CHANGE ORDER NUMBER: 3

Project:	<u>Round Rock</u> 1807-252
Roadway:	<u>San Gabriel Ranch Road</u>
CSJ Number:

**San Gabriel Ranch Road Bridge
Williamson County Project No. 1807-252**

Change Order No. 3

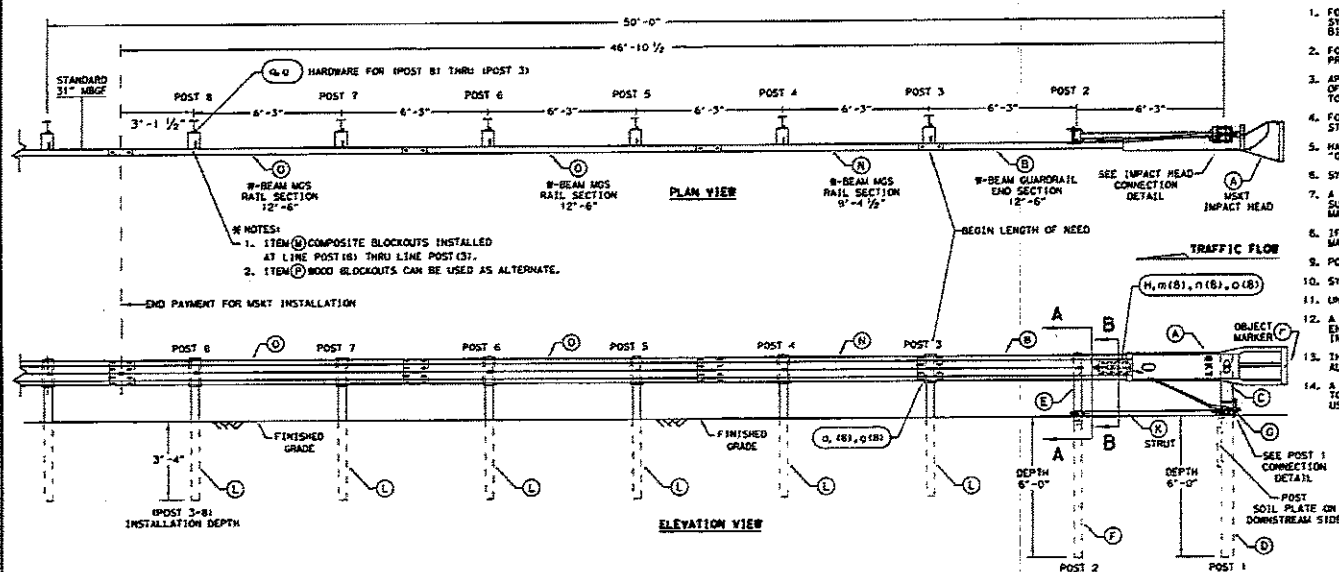
Please see the attached change order for the items listed below. I will need approval on the waterline tie-in by early on Monday to keep that crew moving. Let me know if you have any questions.

1. Changing the guardrail end treatments from SGT to the MSKT per the 4/28/18 TxDOT memo
2. Adding double service waterline tie-in near station 5+00

This CO is being processed, but you have been approved to continue with this work.

Texas Department of Transportation		Design Division Standard	
SINGLE GUARDRAIL TERMINAL			
MSKT-MASH-TL-3			
SGT (12S) 31-18			
FILE: 621263118.dgn	DWG: TxDOT	CAL: M	DWG: VP
DATE: 0001 APRIL 2018	CONT: (SET)	JOB	HIGHWAY
REVISIONS		COUNTY	SHEET NO.
0157

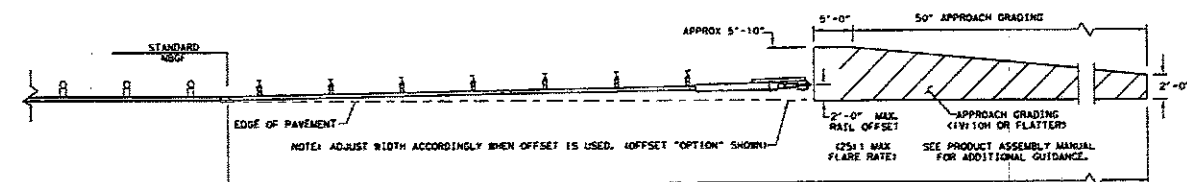
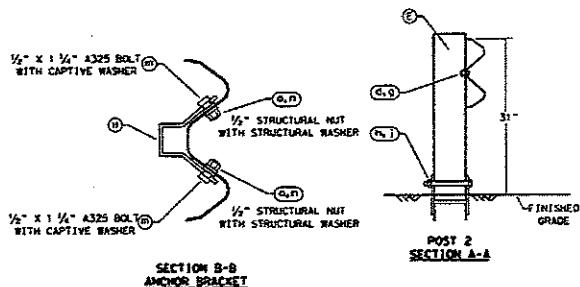
This Change Order also compensates the Contractor for the additional material cost to upgrade guardrail end treatment to TxDOT 2018 standard for crash worthiness per the attached TxDOT memo.

SGT(12S)31-18 The MSKT end terminal is a new standard sheet which depicts a steel post MBGF end terminal system which can be attached to wood or steel post MBGF systems. The system is a re-directive, gating, end terminal system that is proprietary. The system is extruding; meaning the rail panels extrude or spool outwards on the field side upon impact.

This end terminal system is MASH TL-3 compliant, meaning it is available for use for high-speed roadway conditions.
